REVISED RESPONSE TO REQUEST FOR ADDITIONAL INFORMATION**APR1400 Design Certification****Korea Electric Power Corporation / Korea Hydro & Nuclear Power Co., LTD****Docket No. 52-046**

RAI No.: 131-8087
SRP Section: 11.05 - Process and Effluent Radiological Monitoring Instrumentation and Sampling System
Application Section: 11.5
Date of RAI Issue: 08/07/2015

Question No. 11.05-1

11.5 - SRP 11.5.2.2, Description of the PERMSS

Figure 11.5-2Z Location of Radiation Monitors at Plant (Turbine Generator Building El. 170'-0")

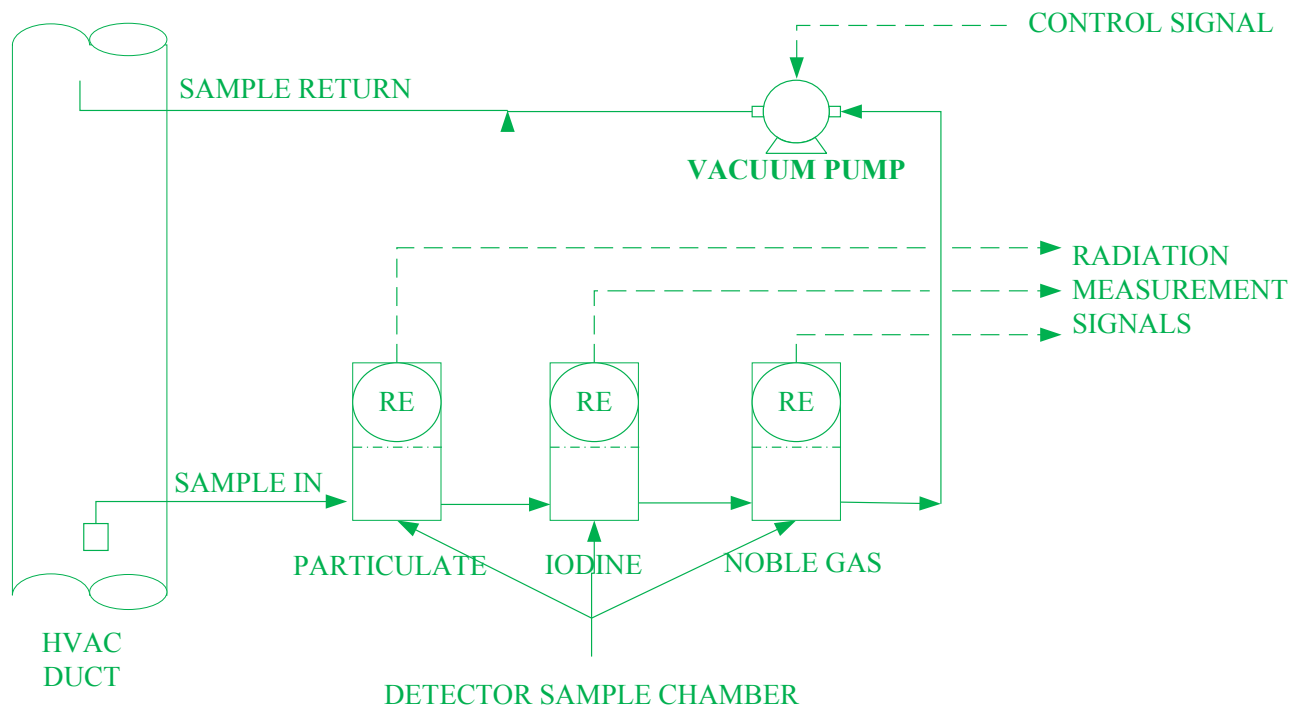
The monitor is located in Turbine Generator Building as shown in Figure 11.5-2Z.
